# Mask Set Errata for Mask 0L33R

This mask set errata applies to the mask 0L33R for these products:

- MC9S08RG60
- MC9S08RG32
- MC9S08RE60
- MC9S08RE32
- MC9S08RD60
- MC9S08RD32
- MC9S08RC60
- MC9S08RC32

**Case 1**

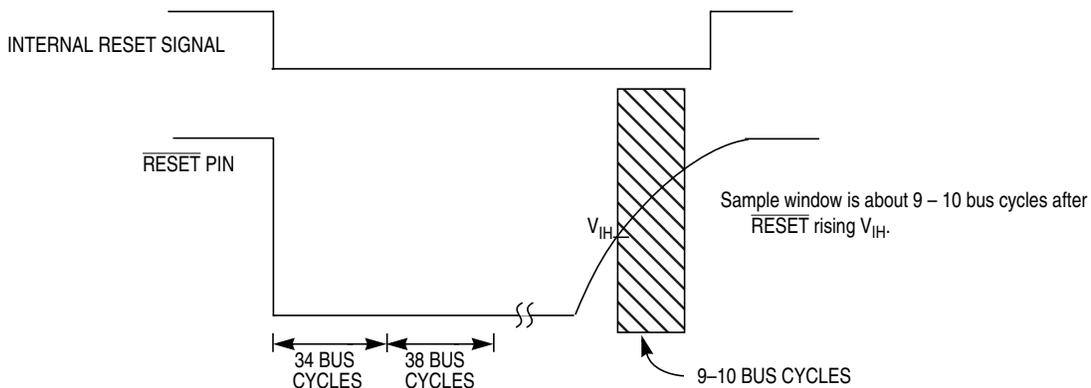
If a falling edge is detected on the external reset pin at either of two sample points, the MCU will cease operation and will recover only after a power-on reset.

**Case 1** — After detecting a reset signal, either internal or external, the internal reset circuit latches the cause of the reset, forces a low level on the external  $\overline{\text{RESET}}$  pin for about 34 bus cycles, releases the pin, and samples the pin level about 38 bus cycles later.

### Workaround — Case 1

To avoid multiple edges on the  $\overline{\text{RESET}}$  pin due to switch contact ringing or EMC noise, eliminate any voltage bounce through RC filtering. A 0.1  $\mu\text{F}$  capacitor to ground and an external 4.7 k $\Omega$  to 10 k $\Omega$  resistor to  $V_{\text{DD}}$  works well to ensure noise suppression.

**Case 2**

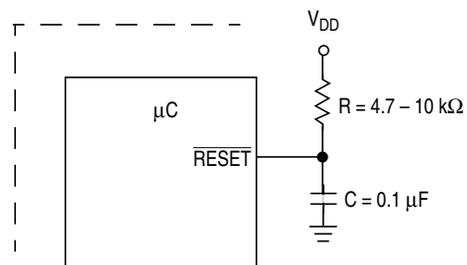
**Case 2** — After remaining in reset for an extended period of time due to an externally applied low level on  $\overline{\text{RESET}}$ , the internal reset circuit will sample the pin level about 9 to 10 bus cycles after the pin raises above its  $V_{IH}$  level.

### Workaround — Case 2

In addition to RC filtering, avoid spurious edges on the  $\overline{\text{RESET}}$  pin caused by external active circuitry such as low voltage detectors and watchdog components. Do this by ensuring that external circuitry cannot drive  $\overline{\text{RESET}}$  low within 10 bus cycles of the release of  $\overline{\text{RESET}}$ .
